Docket Number:	22-BSTD-02
Project Title:	2022 Energy Code Compliance Software && Supporting Documents
TN #:	242743
Document Title:	CASE Team Markup of CEC Draft Nonresidential and Multifamily ACM March 2022
Description:	N/A
Filer:	Patty Paul
Organization:	California Statewide Utility Codes and Standards Team (CASE)
Submitter Role:	Public
Submission Date:	4/21/2022 4:43:59 PM
Docketed Date:	4/21/2022

(Draft) Nonresidential And Multifamily Alternative Calculation Method Reference Manual

For the 2022 Building Energy Efficiency Standards
Title 24, Part 6, and Associated Administrative
Regulations in Part 1.

Figure 8: Example of Lighting Power Fraction Continuous Dimming and Continuous Dimming Plus OFF Daylighting Controls (with Minimum Dimming Fraction of 10 Percent)

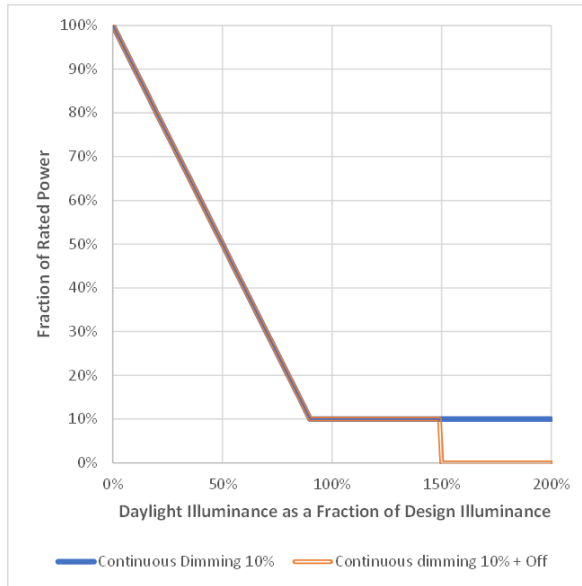
Commented [CU16]: NR daylighting
